| MATERIAL<br>— |                 | CHECKED BY             |            | TITLE<br>TNC50 CABLE PS LMR240                                                        |                                                                                                                                                                                          |                        |
| FINISH<br>—   |                 | SCALE<br>3/1           | UNIT<br>mm |  | A4                                                                                                                                                                                       | DWG NO.<br>CN02192-7/4 |

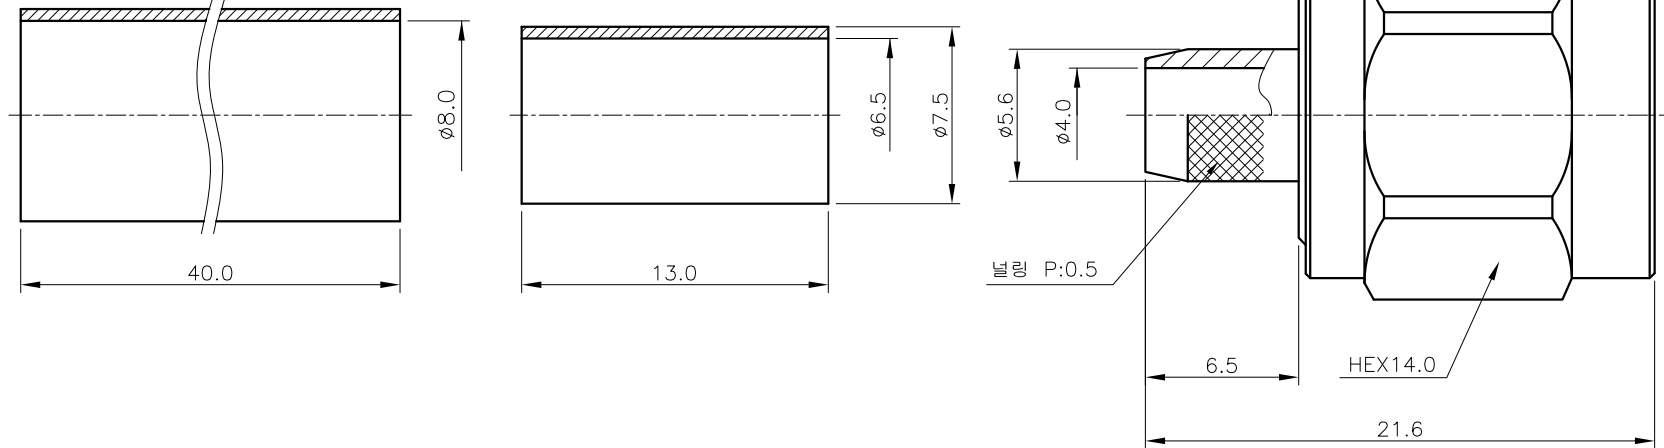
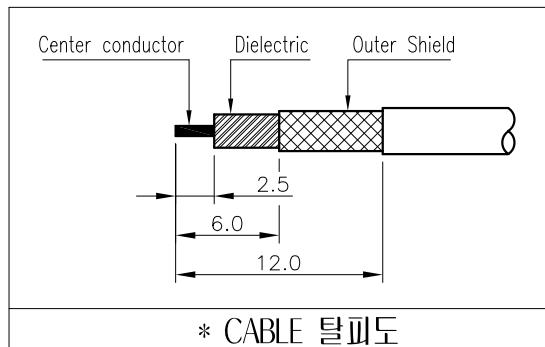
| REVISION |                                                      |         |         |             |
|----------|------------------------------------------------------|---------|---------|-------------|
| 1        | [실변처리No.201803-0008]<br>상대품 체결시 가스켓 돌출현상 없음 -바디,캡 수정 | S.Y.EUN | I.C.KIM | 2018.03.19. |

| 8   | BONDING TUBE | 1    | —                  | —            | ATU00351-N/1                            |
|-----|--------------|------|--------------------|--------------|-----------------------------------------|
| 6   | CAP          | 1    | MBsBD<br>C3604BD-F | Nickel Plate | DCU00135-5/6<br><del>DCU00135-5/1</del> |
| 1   | BODY         | 1    | SUS                | Passivated   | DBD03945-5/4<br><del>DBD03945-5/2</del> |
